B-151456 - Grading

LEGALIZE 11000 CU. YDS. IMPORT FILL IN FLOOD ZONE

RE: Illegal Fill at Adobe Lumber, 5400 Old Redwood Highway

**OVERBANK FLOW ANALYSIS
BASED ON FILL PLACED AT ADOBE LUMBER**

CITY OF PETALUMA FLOODWAY & FLOODPLAIN AREAS

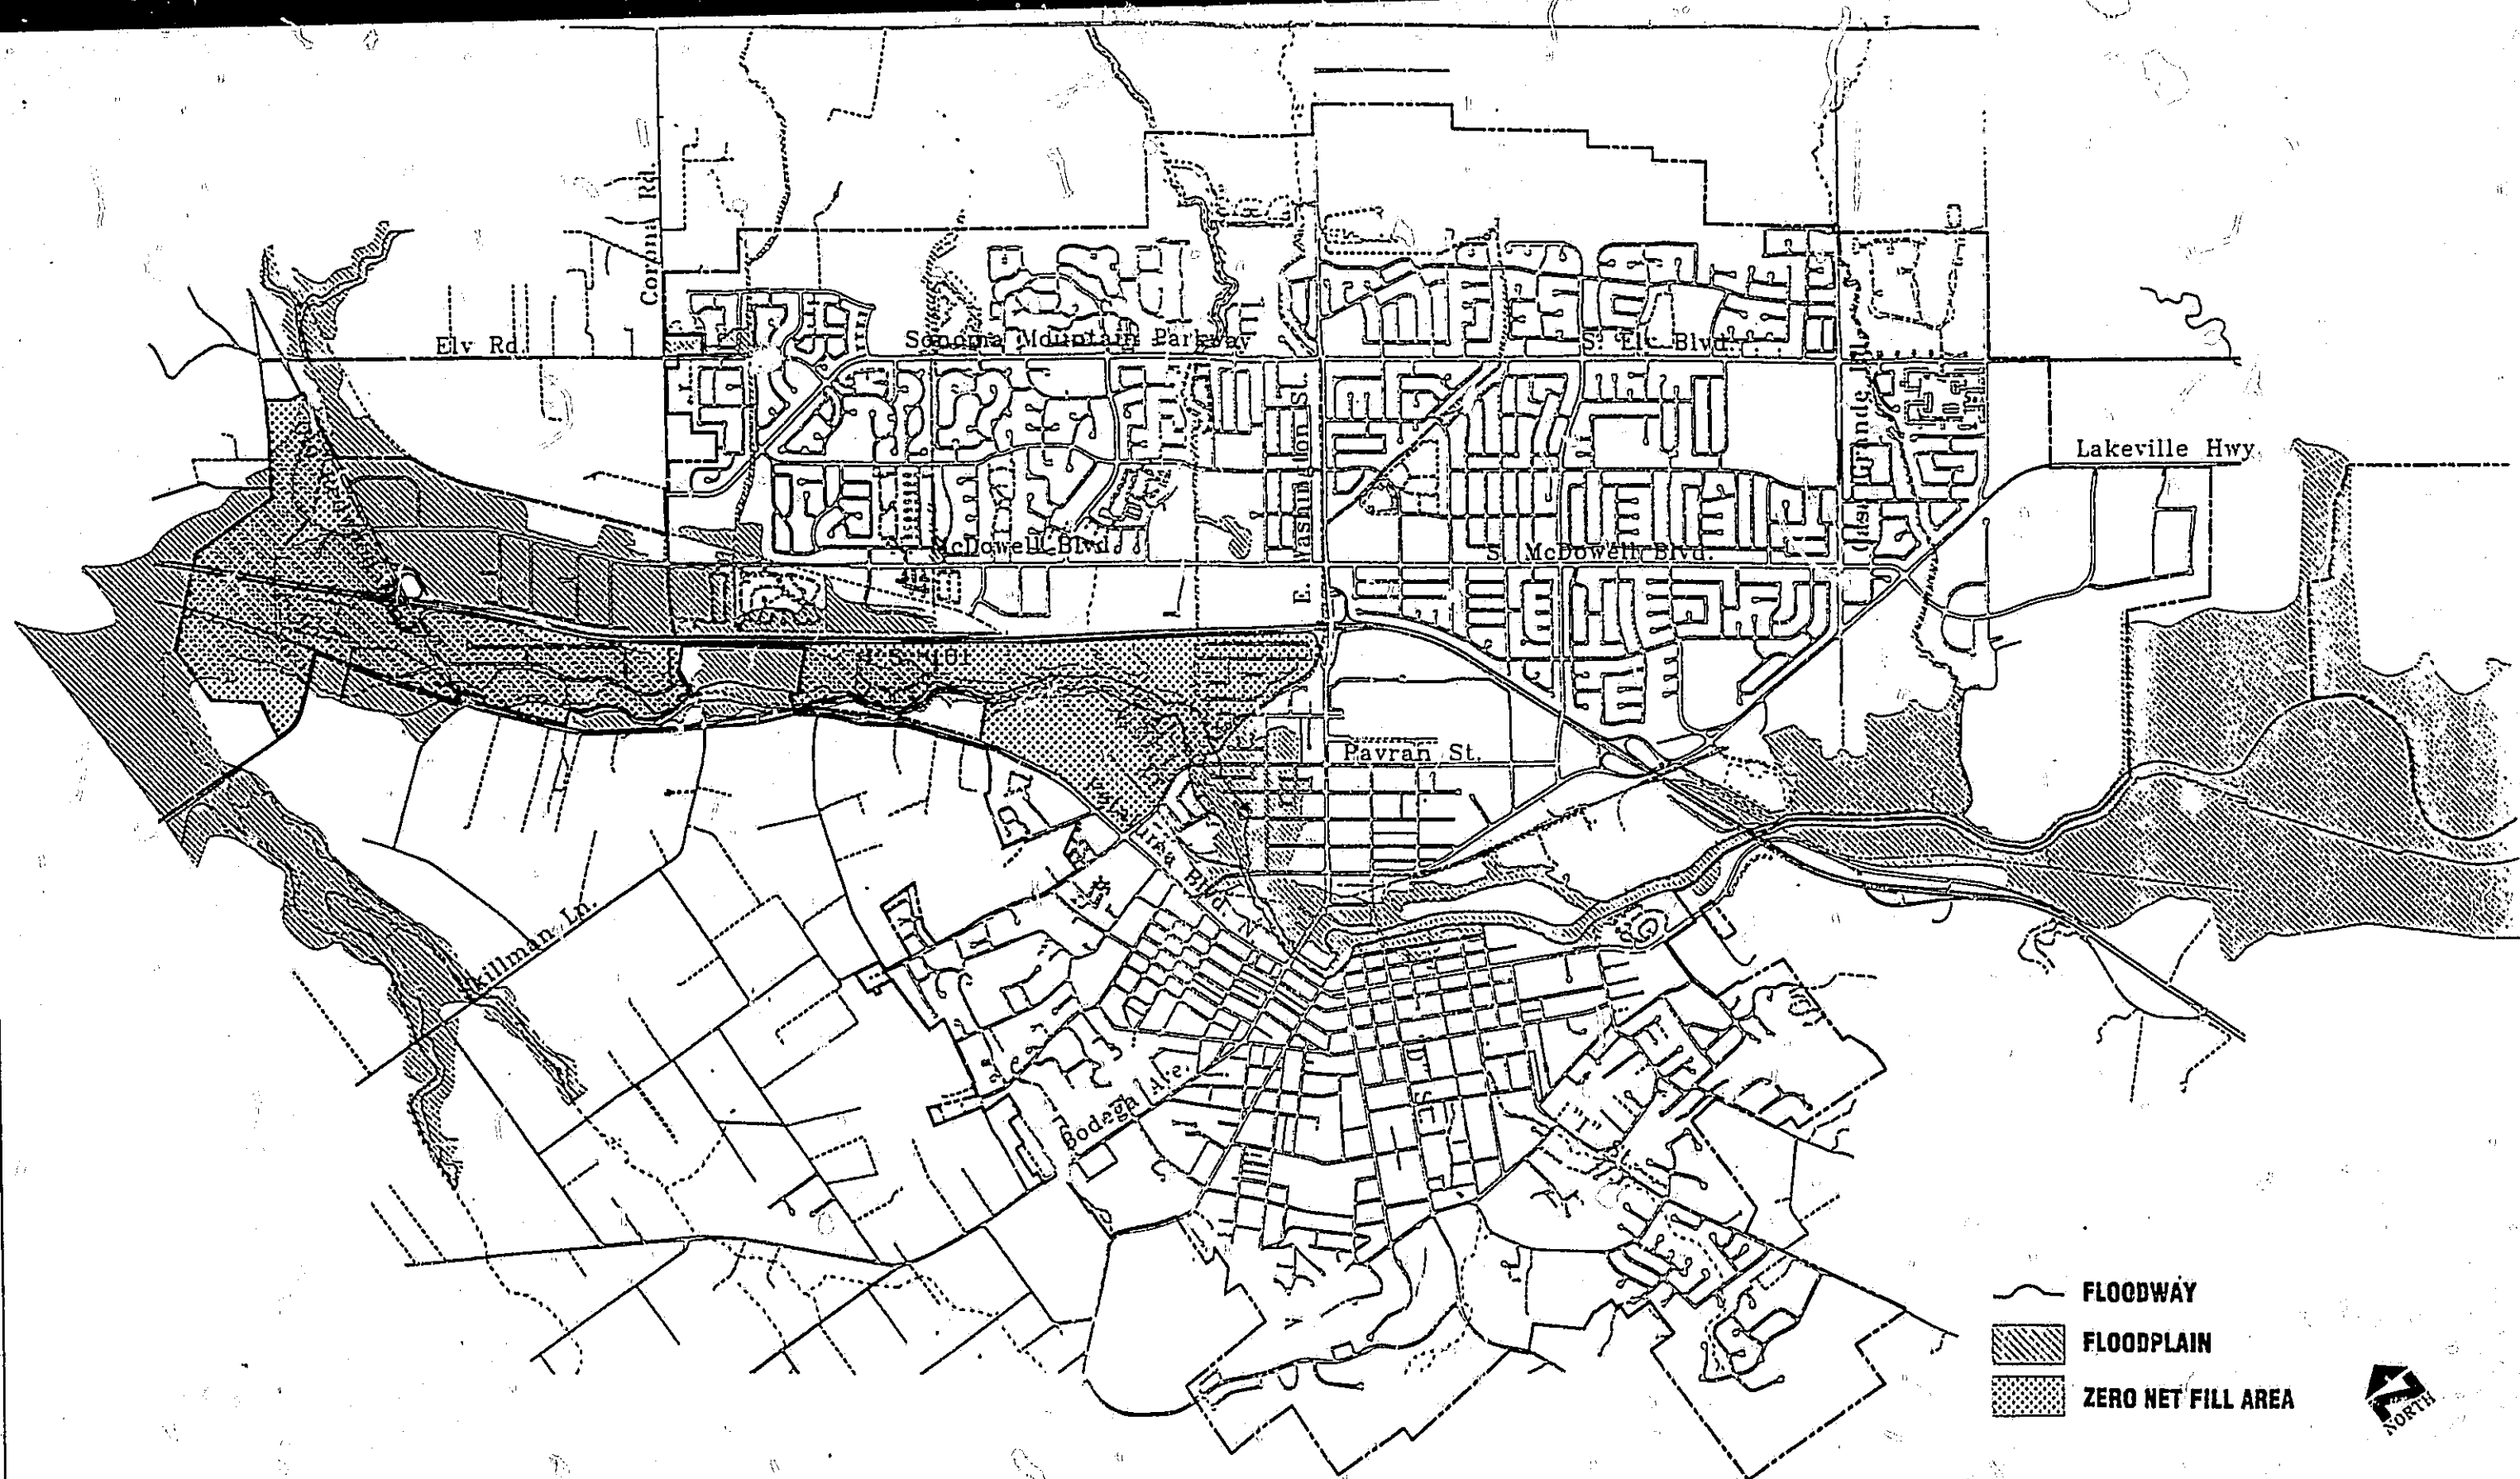
The City of Petaluma Planning and Engineering Departments have had the opportunity to review the plans and overflow analysis provided to the City by the engineering consultants, CSW/Stuber-Stroeh concerning the illegal fill which was placed on the property at 5400 Old Redwood Highway at Adobe Lumber.

It is the City's position that the illegal fill that has been placed on the above noted property could have adverse impacts (flooding) to nearby properties within the city limits. In addition, we believe that adherence with the City of Petaluma "zero-net-fill" regulations would not permit the illegal fill. As has been requested by the City in past letters, please take immediate action to cause the fill to be removed (see attached, letter from Petaluma City Manager, Fredrick Stouder). The Sonoma County Permit and Resource Management should respect and require adherence with these regulations on the subject site.

In reviewing the applicable documents, grading plan, overflow analysis and supplemental information that was provided to the City, it has been noted that the information did not contain a signature and professional engineer's seal. The City's Planning and Engineering Departments are requesting that the documents contain the necessary signature and professional engineer's seal.

Due to potential impacts to the City of Petaluma, the City is also requesting that the county provide documentation indicating that this grading and fill is compatible with the Sonoma County Water Agency Master Plan and/or Future Willow Brook Capital Improvement Projects prior to issuance of any permit.
